## **Grid Code requirements for Power Park Modules Voltage Control and Reactive Power capability A paper by National Grid**

## Appendix – proposed Grid Code modifications

Figure 4

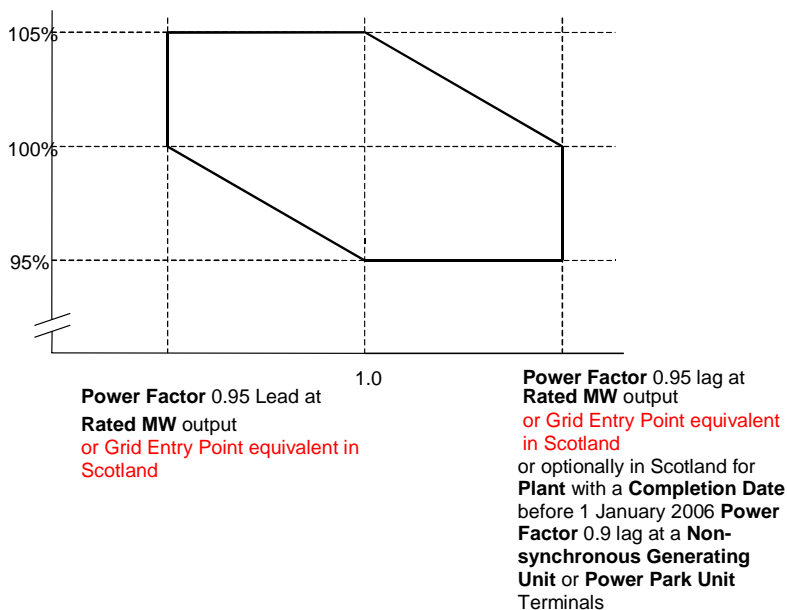
The text of CC.6.3.4 has been modified appropriately in revision 26. However, the title of Figure 4 and the labels on the reactive power output have not been modified and are inconsistent with the text of C.6.3.4 and the reactive capability requirements of CC.6.3.2(c). The title still refers to England and Wales rather than the whole of the GB transmission system and the axis does not reflect the fact that, in Scotland, the reactive power capability requirement of 33kV connected generation is specified at the HV side of the transformer rather than the Grid Entry Point and may not be 0.95 power factor lead/lag at the Grid Entry Point.

- The title of Figure 4 refers to the Grid Entry Point rather than the Grid Entry Point in England and Wales
- The reactive power axis labels of Figure 4 acknowledge that the Grid Entry Point requirement in Scotland may not be 0.95 power factor lead/lag
- The text of CC.A.7.2.2.4 applies the relaxations to the whole GB transmission system rather than England and Wales
- The text of clause CC.A.7.2.2.7 requires the generator to maintain maximum leading reactive current output for voltage rises above 105%.

Voltage at **Grid Entry Point** in England and Wales or **User System Entry Point** if **Embedded** (% of Nominal) at 33 kV and below
